TECHNICAL EVALUATION REPORT

VERRIDE AND RESET OF CONTROL CIRCUITRY IN THE VENTILATION/PURGE
ISOLATION AND OTHER ENGINEERED SAFETY FEATURE SYSTEMS (B-24)
PORTLAND GENERAL ELECTRIC COMPANY
TROJAN NUCLEAR PLANT

NRC DOCKET NO. 50-344

August 4, 1982

Figure 1. CVI Actuation/Reset

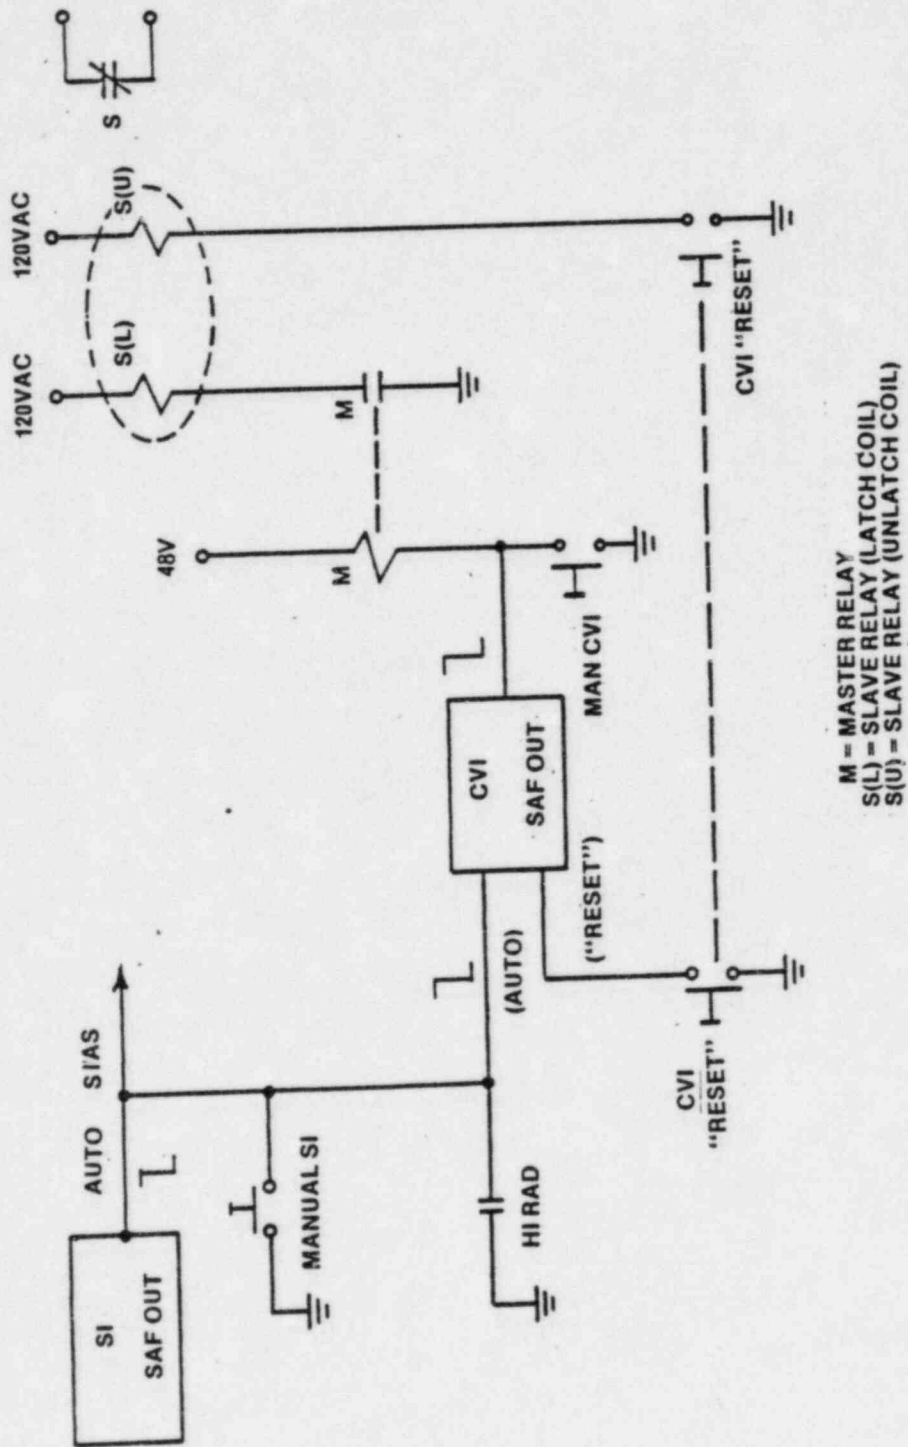
As shown in Figure 1, SI actuation (automatic and manual) and high radiation CVI initiation signals are combined to provide a single input to a logic device (SAF-OUT board) in each electrical train. These output devices consist of a "resettable" solid state latching circuit with a power conditioning output circuit and are each used to drive a master relay coil. The contacts of the master relay control the latching-type slave relays, which have contacts in the individual control circuits for the solenoid and motor operators used to position ESF valves and dampers.

A manually operated "RESET" pushbutton actuates the unlatch coils of the slave relays and provides a "reset" signal to the solid state logic circuit. A "reset" signal causes the SAF-OUT logic circuit to remove the actuation signal from the master relay and to go to a signal-blocking mode until all initiating signals have been removed (e.g., measured isolation parameter value returns to normal). Thus, the "reset" feature of the solid state protection system SAF-OUT logic unit behaves as an override which defeats all automatic signals if initiated with an actuation signal present. The manual SI actuation signal automatically actuates the CVI system and thus is affected by this override. The manual CVI signal, however, is downstream of the CVI SAF-OUT board and thus is not affected by an override of the CVI logic.

The CVI system at the Trojan plant does not satisfy Criterion 1. Actuation of the system "RESET" provided for the CVI SAF-OUT device, with an input signal present, will deenergize the master relay and unlatch the slave relays for the purge isolation valves, allowing the valves to be reopened with an isolation signal present. Further, "RESET" actuation will prevent a second isolation signal (e.g., safety injection after containment high radiation) from initiating CVI until the first signal has cleared.

Figure 2. Motor-Operated Valve Control Circuitry

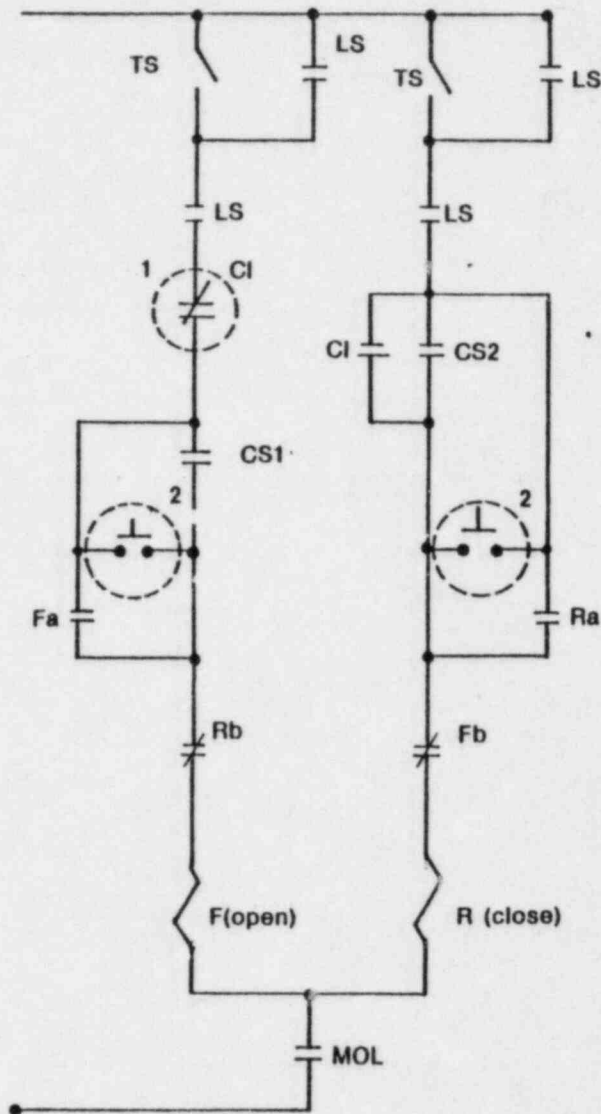
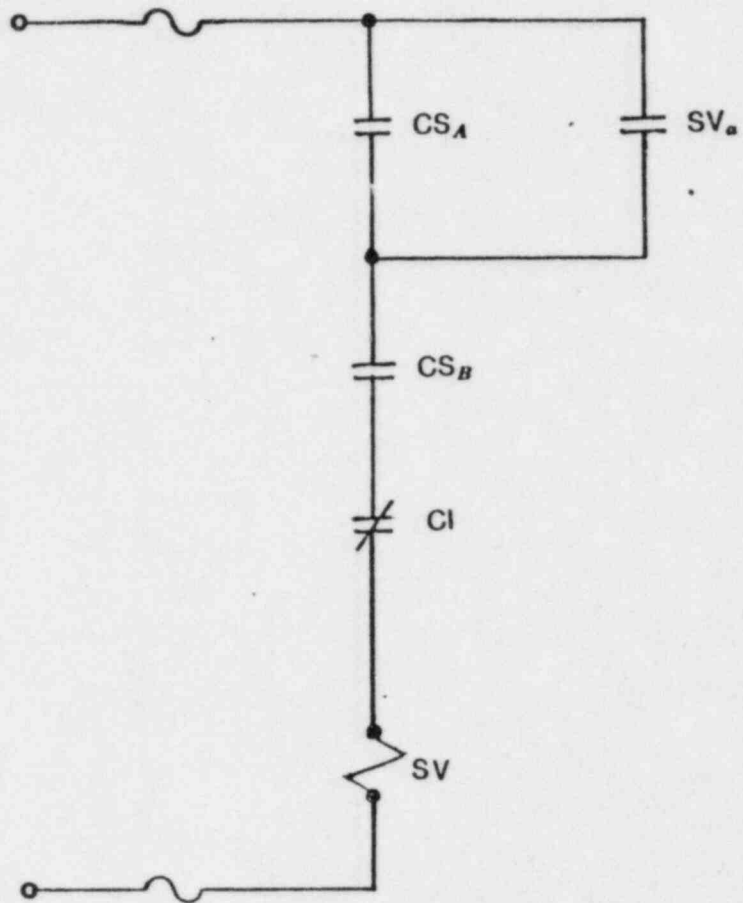
Control circuits for motor-operated (full voltage reversing motor controllers) purge supply and exhaust valves, shown in Figure 2, are designed to be opened only by actuation of an individual valve control switch. Valve control switches have contacts in both the opening and closing relay circuits, which

are open whenever the switch is in its neutral/normal position. Since these switches are spring returned to neutral, with the closing contact bypassed by the appropriate slave relay contact when an isolation signal is present, manual switch motion is necessary to energize the opening coil following the clearing of the isolation signal. Further, a normally closed slave relay contact in the "open" relay circuit prevents momentary valve motion should the local control switch be placed in the open position with a CVI signal present.

Figure 4. Feedwater Isolation Actuation/Reset

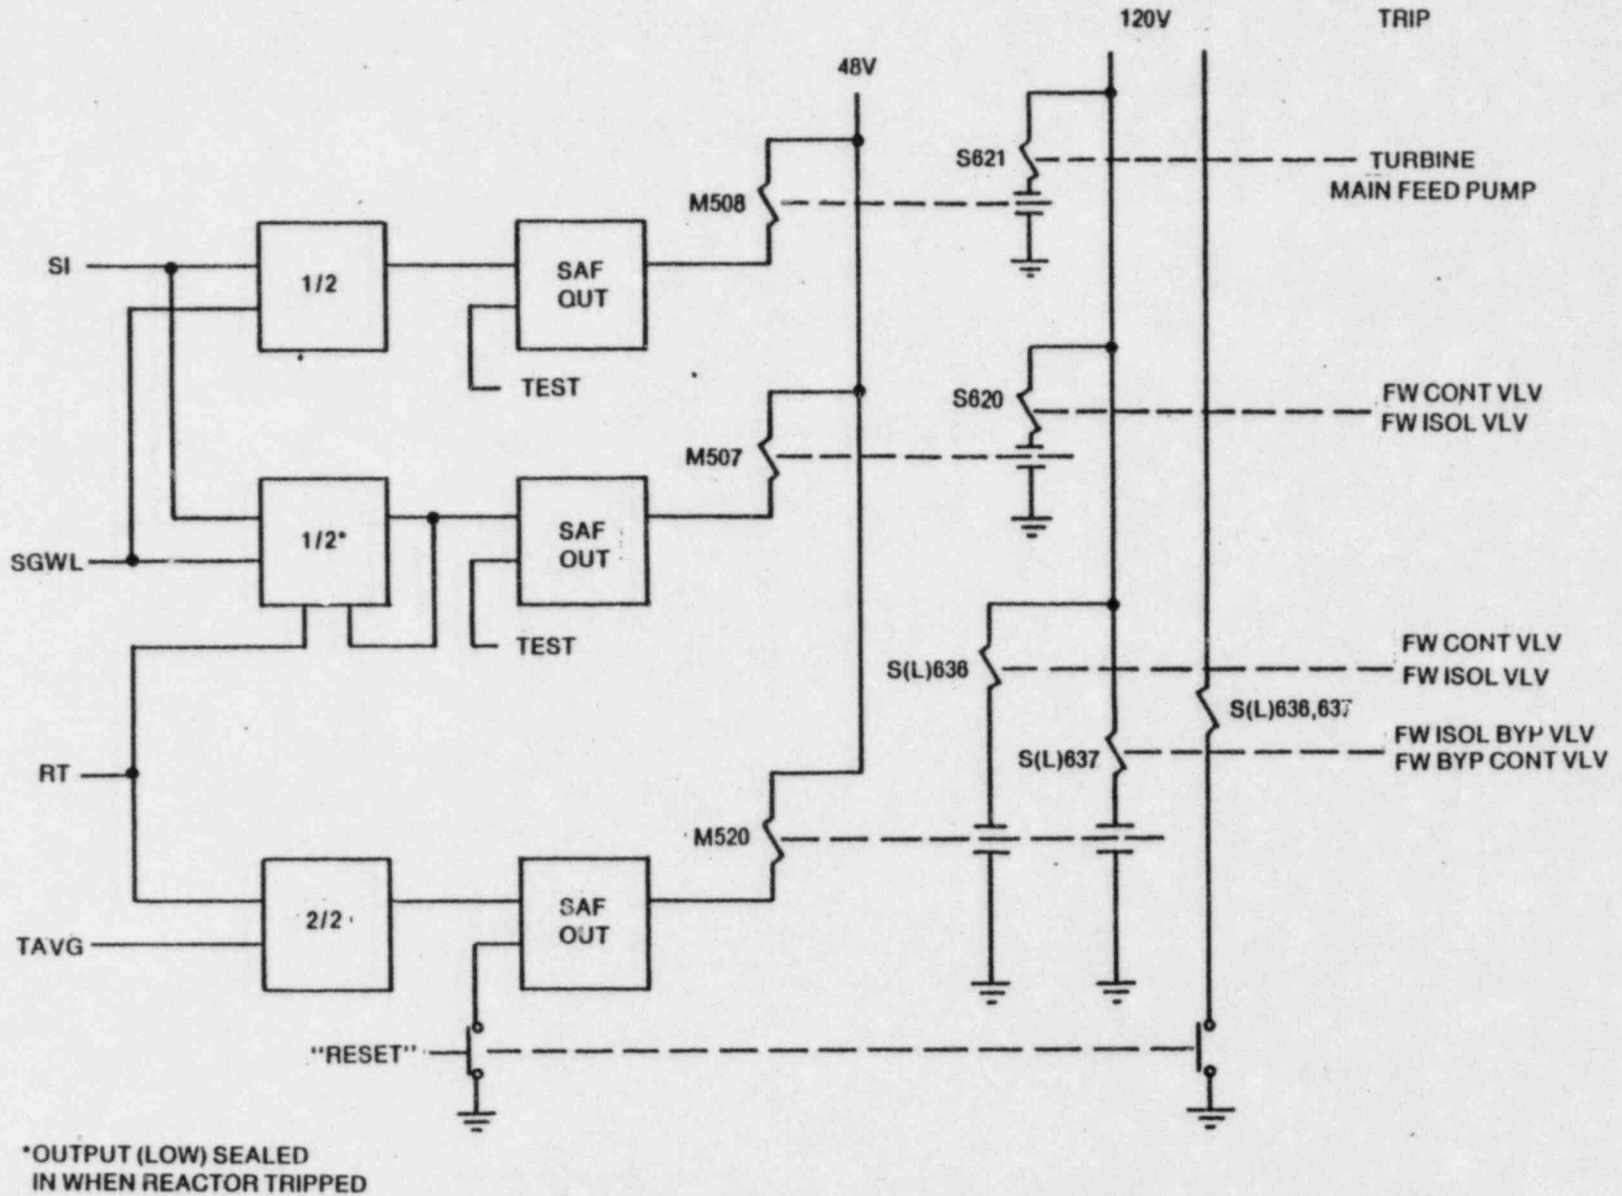
ESF circuitry at the Trojan plant does not conform to Criterion 6 since the resetting of certain feedwater isolation signals will cause the feedwater flow control and bypass flow control valves to change position. This condition, however, could be found acceptable by NRC staff, considering the explanatory information provided to supplement Criterion 6, on the basis of the following (refer to Figure 4):

- o If feedwater system isolation is initiated by either SI or high steam generator water level (SGWL), the feedwater flow control valves cannot be reset via a "RESET" pushbutton. Clearance of the initiating signal is required.
- o Both SI and SGWL signals will also trip the main feed pumps and feedwater isolation valves, neither of which will change position as a result of initiating signal clearance.
- o When either SI or SGWL signals are accompanied by or followed by a reactor trip, the feedwater flow control valves will not reposition until the initiation signal has cleared and the reactor trip reset.

- o If feedwater isolation is initiated by low Tav_g in conjunction with a reactor trip, the feedwater flow control valves and bypass flow control valves will reposition upon use of a pushbutton RESET. This action will not, however, cause the repositioning of the feedwater or feedwater bypass isolation valves and thus will not affect flow to the steam generators. Further, this subsystem is provided as an operational aid to prevent excessive cooldown. It is not provided to mitigate an accident following which the position of these control valves is critical (e.g., main steam line break) and which is not accompanied by the ESF signal (i.e., safety injection) provided for that accident. The classification of this signal as an operator aid rather than as an engineered safety feature, even though it is included in the SSPS system, is supported by the fact that low Tav_g in conjunction with reactor trip will not trip the turbine or main feed pumps and thus cannot be considered a steam generator (i.e., safety-related) isolation signal.
